REF: NIMDC/ANPARA-05

SUB: STUDY OF HIGH SHAFT VIBRATION PROBLEM OF TG#6 [500 MW]

PRELIMINARY REPORT ON ANPARA TPS TG#6

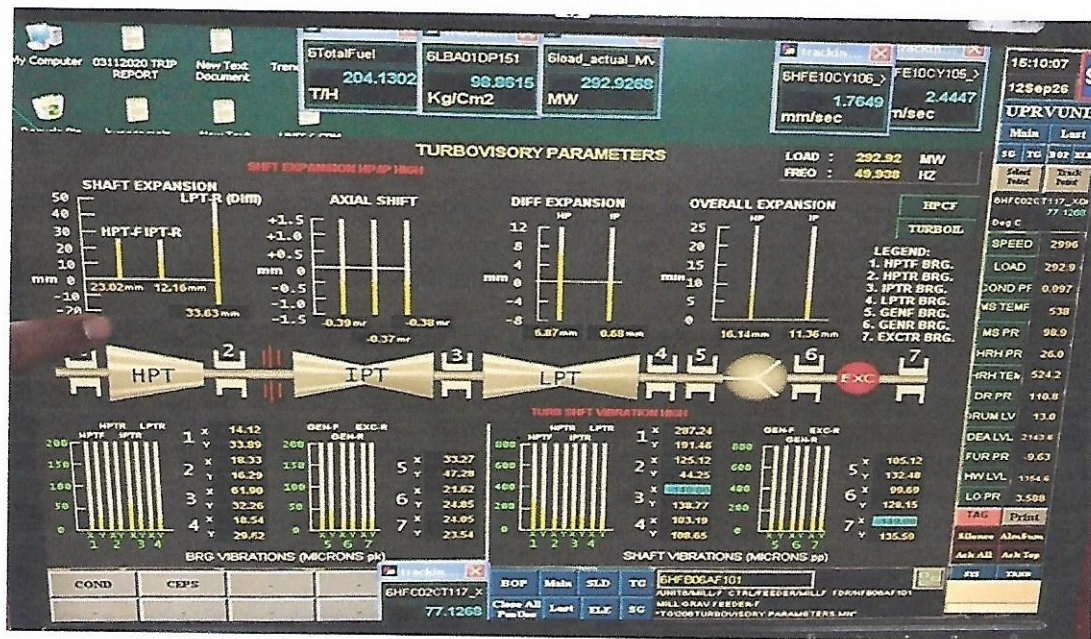
- a) **Orbit Plots:** The orbit recorded at bearings 1, 2, and 3 shows that bearing no. 2 is heavily preloaded, with a clear, elongated, banana-shaped trajectory and a dense, concentrated trace, indicating severe mechanical preload or shaft misalignment. The flattened orbit indicates that the shaft is heavily constrained in one radial direction, preventing it from forming a normal circular or elliptical orbit.

Secondary Indicators: The loop crossover (often appearing like a figure-8 or a loop-within-a-loop) in the orbit pattern indicates the presence of strong non-linear forces, typically caused by extreme reaction forces that push the shaft beyond acceptable limits.

Journal Centerline and Eccentricity Analysis: To validate, severe directional preloading on Bearing No. 2 and evaluate the hydrodynamic oil film condition, we calculate the Eccentricity Ratio (ϵ) and Attitude Angle (ϕ). These metrics are integrated into the Bently system. The presentation explained the EC ratio. Details are below.

5.1 QUANTIFICATION OF ROTOR STIFFNESS REDUCTION DELTA K

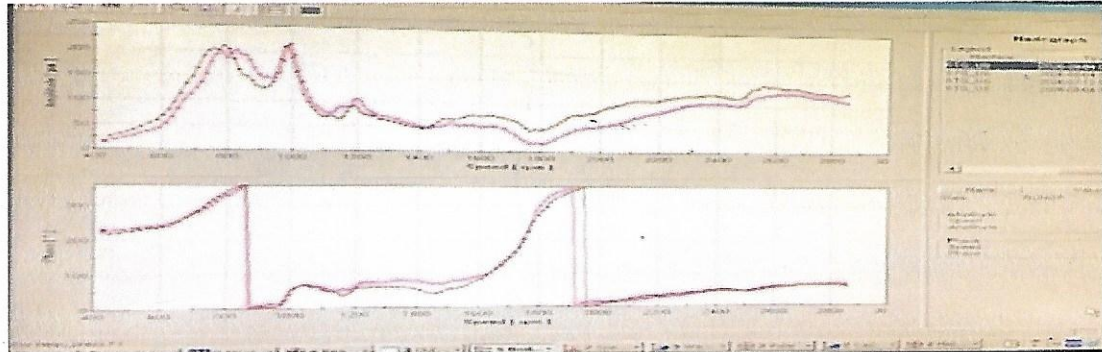
The historical Bode plot suggests that BRG No. 1 & 2 are operating within normal parameters; however, a critical speed shift is noted for (IPT) BRG No. 3, from 895 to 827, likely due to split resonance caused by bearing asymmetry. The critical speed shift is accompanied by an amplitude dip and is caused by split resonance.

This 14.62% reduction represents an enormous structural shift for a massive 500 MW machine. Standard residual unbalance cannot cause this, indicating a substantial loss of the system's geometric constraints or load-bearing capability at Bearing No. 3.

Potential issues may stem from structural degradation beneath the pedestal, including cracked or deteriorated epoxy/cementitious grout, loose or broken foundation anchor bolts, or damage to the bearing housing support structure/pedestal seat.
